NUMBER: 23-017-18

Headlamp Condensation and Fogging

This bulletin involves installing updated vent caps on the headlamp assembly.

2011 - 2017	(LD)	Dodge Charger
2015 - 2017	(LA)	Dodge Challenger
2011 - 2017	(LX)	Chrysler 300

Fig. 3
Example Location Of Vent Caps - Charger

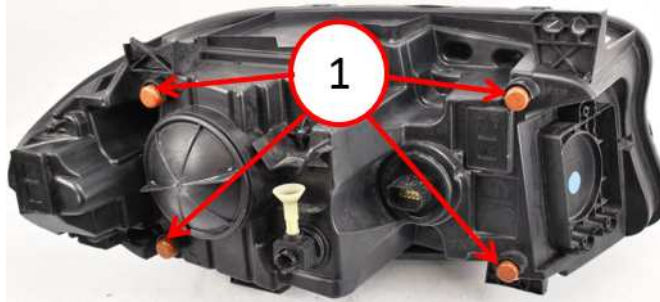
1. Remove the headlamp assembly. Refer to the detailed service procedures available in DealerCONNECT> TechCONNECT> 8L - Lamps and Lighting / Lamps/Lighting - Exterior / Unit, Front Lamp/Removal.
2. Remove and discard the old vent caps by pulling them rearward off the headlamp assembly (Fig. 3) .

1 - Four Old Style Vent Caps

3. Install the new (brown) vent caps by pushing them on the bosses of the headlamp assembly.
4. Install the headlamp assembly. Refer to the detailed service procedures available in DealerCONNECT> TechCONNECT>08 - Electrical/8L - Lamps and Lighting/Lamps/Lighting - Exterior/Unit, Front Lamp/Installation.
